**Zoning By-law Amendment ZB02-25
Response to 1st Submission Comments, Revised January 27, 2026
For a 5-Storey, 10 Unit Residential Condominium Building
At 86 John Street**

Response to 1st Submission Public Agency Comments

Port Hope Planning Comments, email dated June 18, 2025

45 DEG. ANGULAR PLANE
AT EXTREME WEST SIDE
OF PROPOSED BUILDING

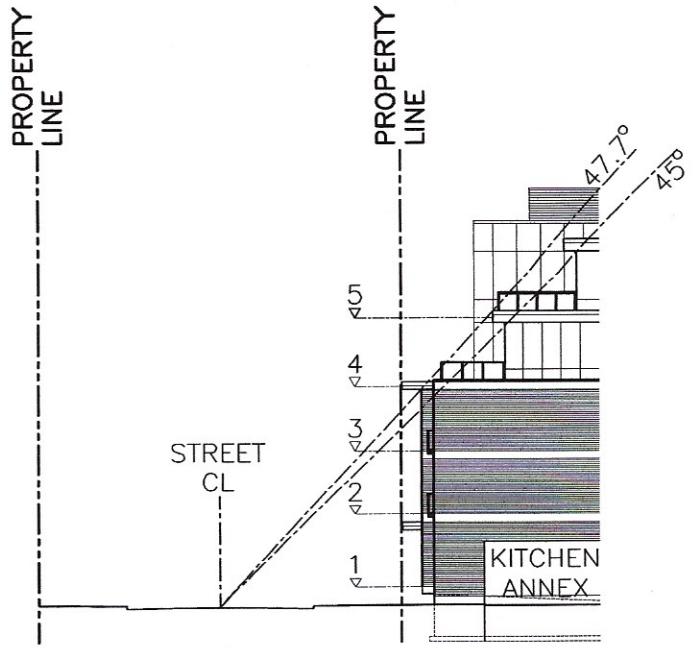
A series of comparison **angular plane** section diagrams and a written description of the results were prepared in response to the 1st Submission Planning Comments. To graphically illustrate the impact, the angular plane diagram is appended and is also included in Figure 16 on page 74 of the revised HIA report. The following text describing the results of the angular plane study is included in the HIA report as well:

Referring to the top 2 section diagrams, the angular plane of the 3-storey base of the west portion of the building is 44.3 degrees, while the angular plane of the east portion is 47.7 degrees. The center section of the building that divides the base into 2 sections was not considered, as it is a narrow portion. Its height can be reduced by switching the position of the exit stair with the elevator. This will be explored further during the detailed design stage.
